From: Curtis, Taylor L. <taylor_curtis@fws.gov>
Sent: Monday, February 6, 2023 9:23 AM
To: Nick Koutoufidis
Cc: Zoutendyk, David
Subject: Piraeus Point- Draft Environmental Impact Report; MULTI-005158-2022

In Reply Refer to:
 22-0052035-CEQA_SD

Subject: Comments on the Draft Environmental Impact Report for Piraeus Point Project,
 City of Encinitas, San Diego County, California

Figure 1. Regional Location: Cannon Property, Encinitas

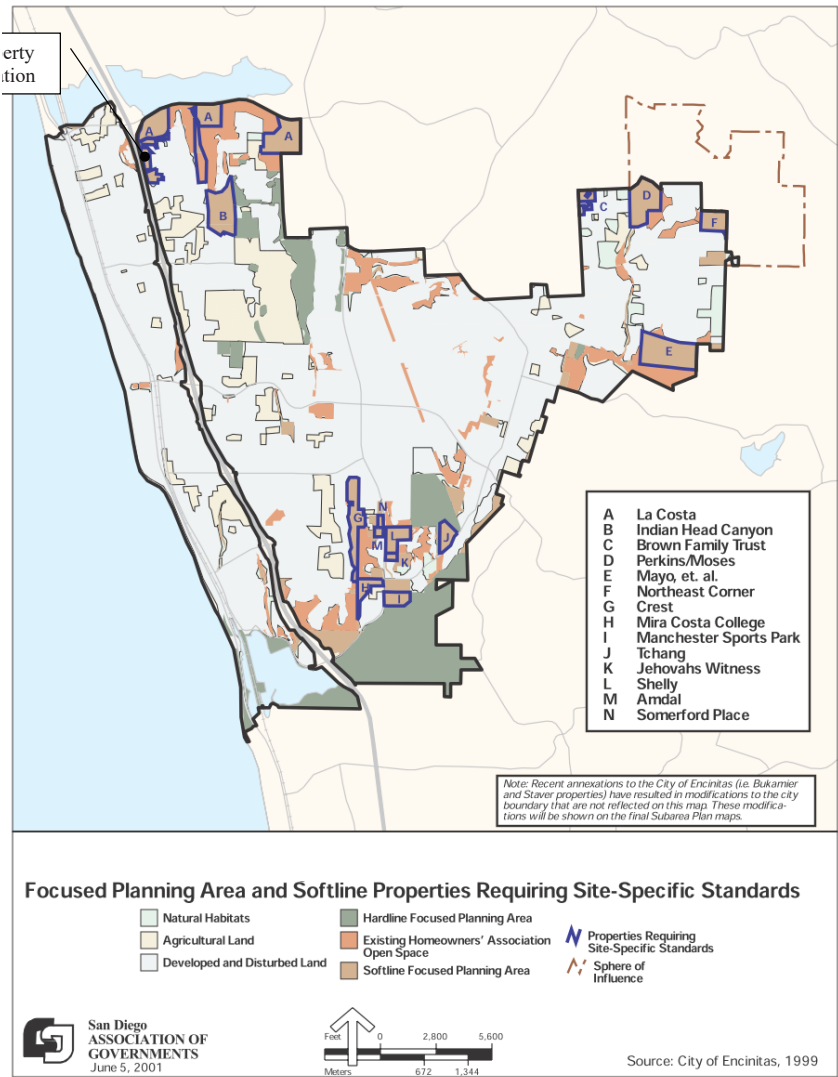
These standards (number of gnatcatchers, etc.) refers to the entire La Costa Softline FPA region (see Figure 1, "A"), not specifically this site.

At this point, I recommend restricting all development to the least sensitive areas of the site. These are clearly the FA areas, especially on the southern portion of the site. Although this area supports a patch of CSS, it is not directly connected to any natural areas and thus subject to edge effects. For this reason, you may have the opportunity to remove this habitat by offsetting that loss on sensitive areas to the north.

Refer to Response 1B-11, above. No change to the EIR discussion or findings is required based on this comment.

PIRAEUS POINT
ENVIRONMENTAL IMPACT REPORT
Biological Survey Results - Plants
Figure 3.3-3

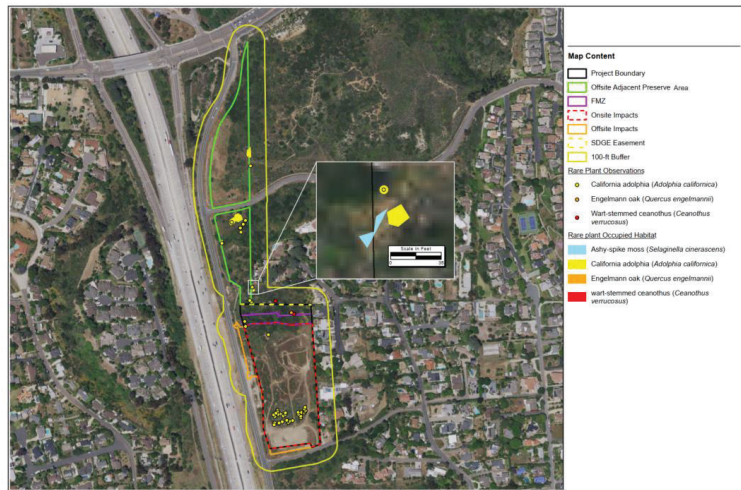
The comment is a conclusion to the comment letter and provides contact information for CDFW representatives as well as an attachment of Figure 3.3-3, Biological Survey Results – Plants, as provided in the EIR.

Appendix 2- Possible TRAFFIC MITIGATION: Piraeus northbound at La Costa Ave.

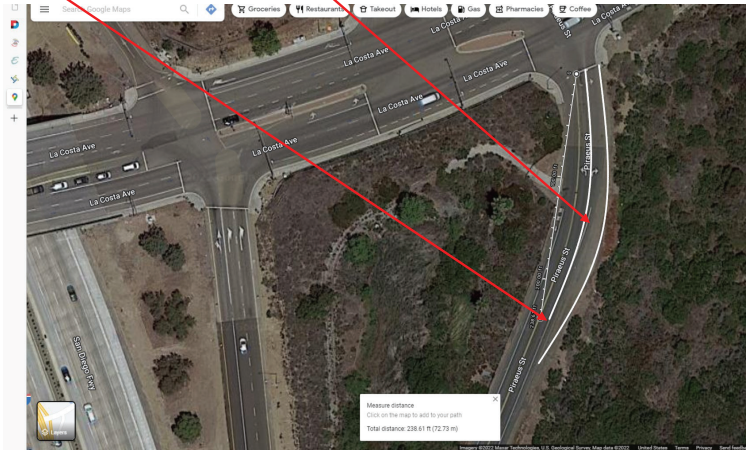
Google Maps view of Piraeus St intersection with La Costa Ave. Overlaid measuring scale shows the EXISTING approximately 100-foot-long turn lanes on Piraeus, which cause a backup queue once 4 or 5 cars are in the left turn lane.

Google Maps view of Piraeus St intersection with La Costa Ave. Overlaid measuring scale and white lines shows SUGGESTED FUTURE paving of the shoulder to allow extension of the turn lanes to approximately 250 feet in length to reduce the queue that forms at peak traffic times.

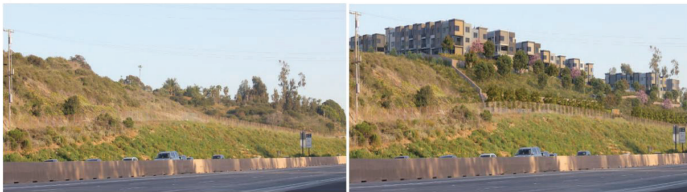
The Act also requires protection of views and to minimize alteration of natural landforms, to be visually compatible with the character of surrounding areas. Does this image look as it is compatible with the surrounding area? The entire Scenic Visual I-5 Corridor looks as the image on the left, not with high density three story buildings as on the right. The visual corridor needs its protections and limitations on development to be considered and honored. Ask the draft EIR to address this.

A 40 percent encroachment into the bluff should be denied. It totally removes virtually all the slope and 60,000 cubic yards of soil. It eliminates any natural slope and sensitive biologicals. It is an obliteration to the site and requires excessive grading. It violates the Sixth Cycle Housing Element Goal 2.7. and the EIR ignores section 30251 of the Coastal Act. You cannot, in good conscience, approve cutting into the slope and allow for this severe, site destructing grading and should reevaluate its results based on enforcing 30251 and deny this project site as useable for this project.

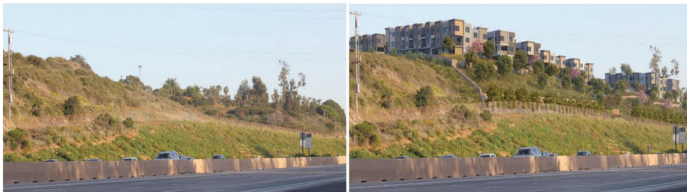
The Act also requires protection of views and to minimize alteration of natural landforms, to be visually compatible with the character of surrounding areas. Does this image look as it is compatible with the surrounding area? The entire Scenic Visual I-5 Corridor looks as the image on the left, not with high density three story buildings as on the right. The visual corridor needs its protections and limitations on development to be considered and honored. Ask the draft EIR to address this.

A 40 percent encroachment into the bluff should be denied. It totally removes virtually all the slope and 60,000 cubic yards of soil. It eliminates any natural slope and sensitive biologicals. It is an obliteration to the site and requires excessive grading. It violates the Sixth Cycle Housing Element Goal 2.7. and the EIR ignores section 30251 of the Coastal Act. You cannot, in good conscience, approve cutting into the slope and allow for this severe, site destructing grading and should reevaluate its results based on enforcing 30251 and deny this project site as useable for this project.

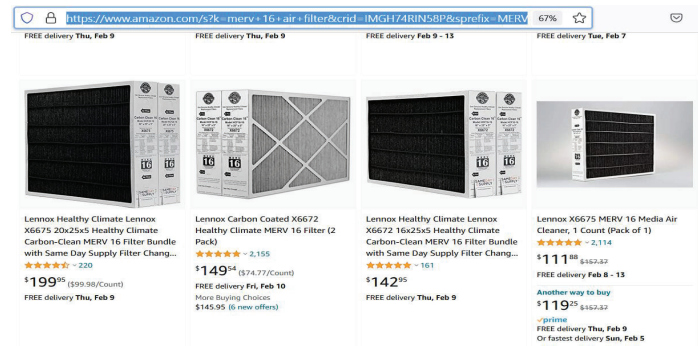
Due to constant high noise levels generated from the I-5 Freeway, easterly winds, and site located less than 200 meters from the freeway, it is highly probable that windows will be closed at all times. Can the draft EIR confirm this is probable?

The windows proposed for the Clark Apartments on its freeway facing side will be impossible to open. Permanently shut. Odors generated and contained within the Piraeus Point residences, despite the use of sophisticated MERV 16 air filters, may well be in the realm of mimicking an NBA/NFL locker room over time (humor intended).
